LONG BEACH MEMORIAL MEDICAL CENTER EXPANSION  
VOLUME III, ENVIRONMENTAL IMPACT REPORT  
SCH NO. 2004081142

**SECTION 12.0**  
**CLARIFICATIONS AND REVISIONS TO THE**  
**DRAFT ENVIRONMENTAL IMPACT REPORT**

Section 12.0 consists of clarifications and revisions to the Draft Environmental Impact Report (EIR), which have resulted from responses to comments received from agencies and the public. All clarifications and revisions to the Draft EIR were made to increase the understanding of the EIR. The Draft EIR was released for a 45-day public review period between January 25 and March 10, 2005, and the City of Long Beach received 19 letters of comment on the Draft EIR.

**FIGURE R2.4.3-1**  
Miller Children's Hospital Expansion

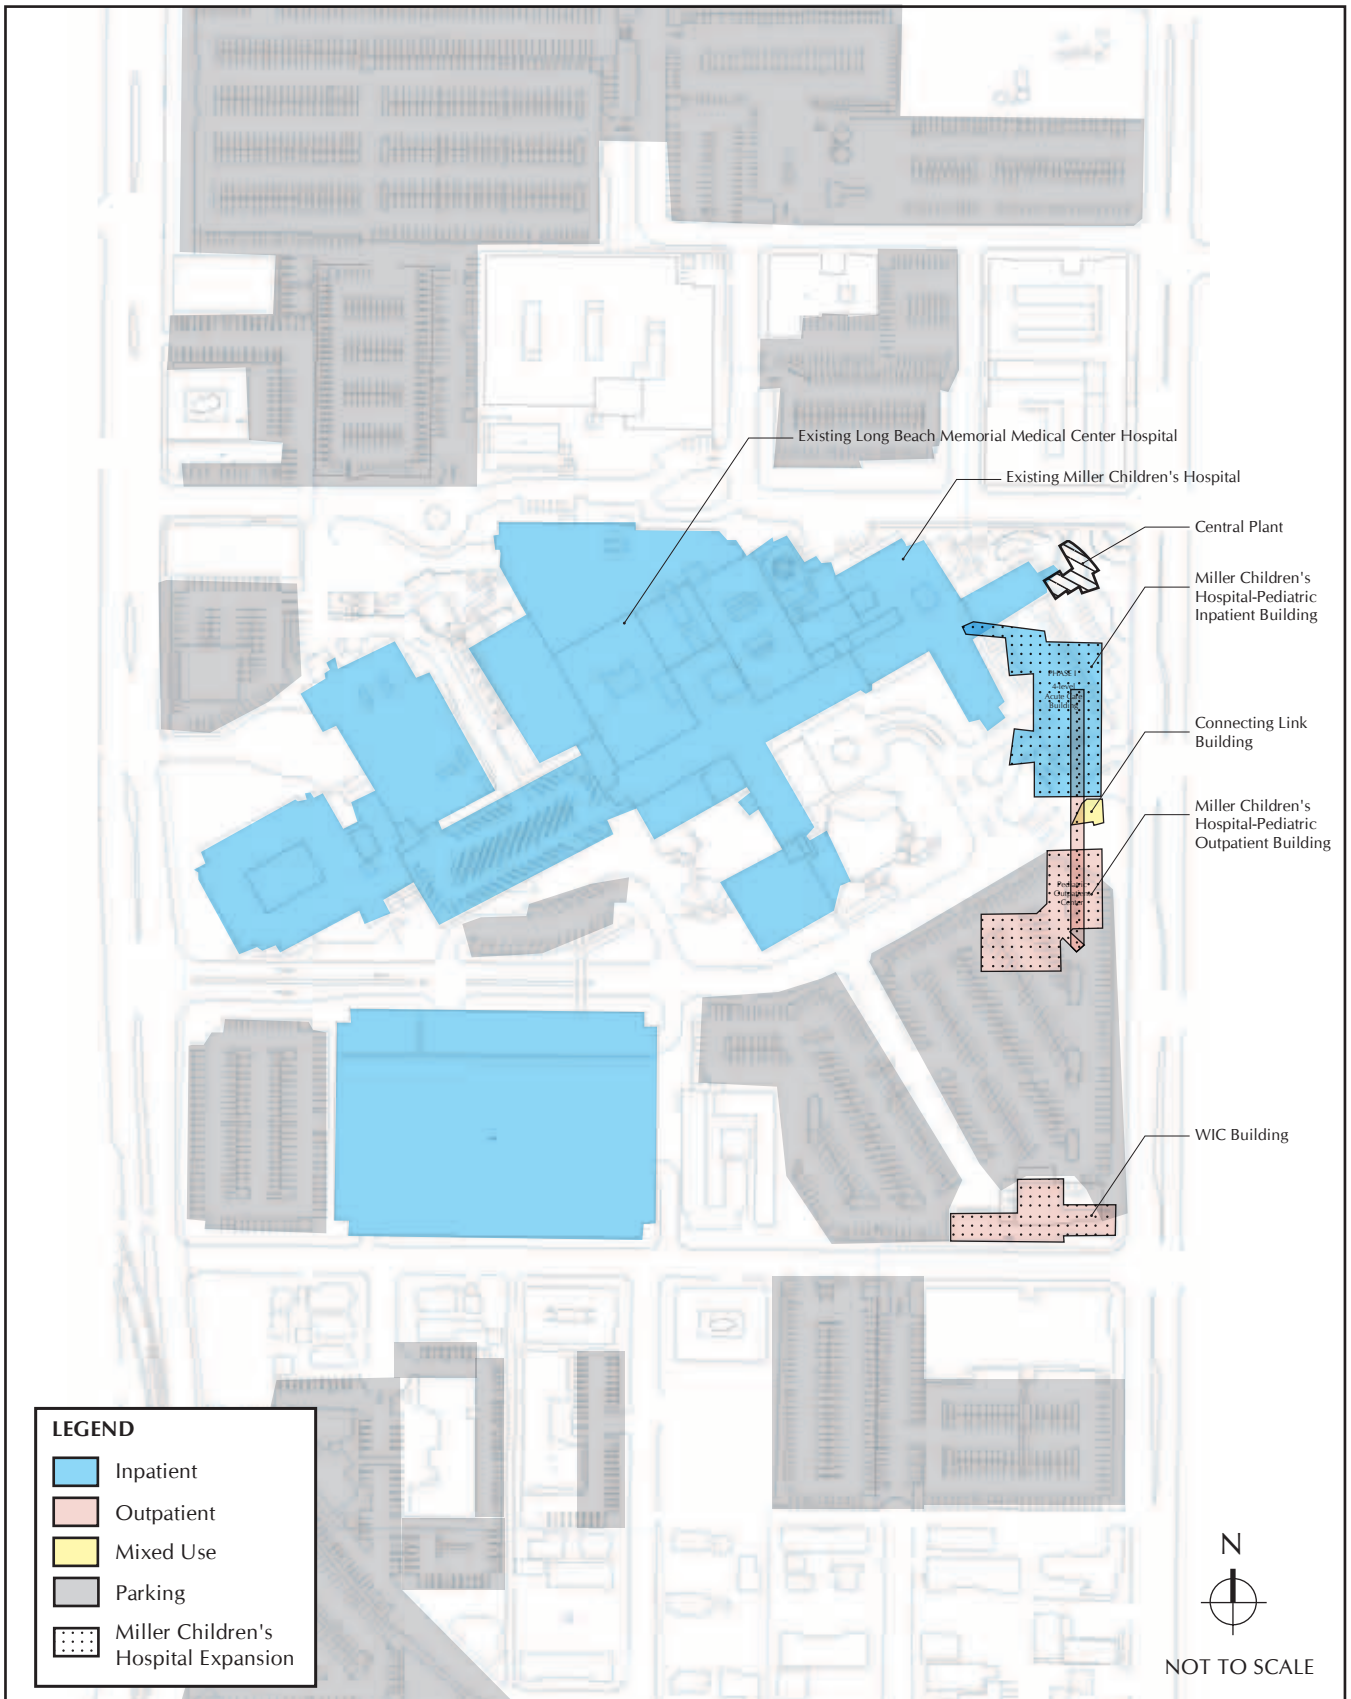
Page 2-9 The central plant building and utility trench were relocated from the Parking Lot L location shown in Figure 2.4.3-1 to an area southwest of the intersection of Columbia Street and Atlantic Avenue as depicted in Figure R2.4.3-1.

In the first sentence of the first paragraph under this heading, please replace the reference to (Figure 2.4.3-1, *Miller Children's Hospital Expansion*) with the following:

(Figure R2.4.3-1, *Miller Children's Hospital Expansion*)
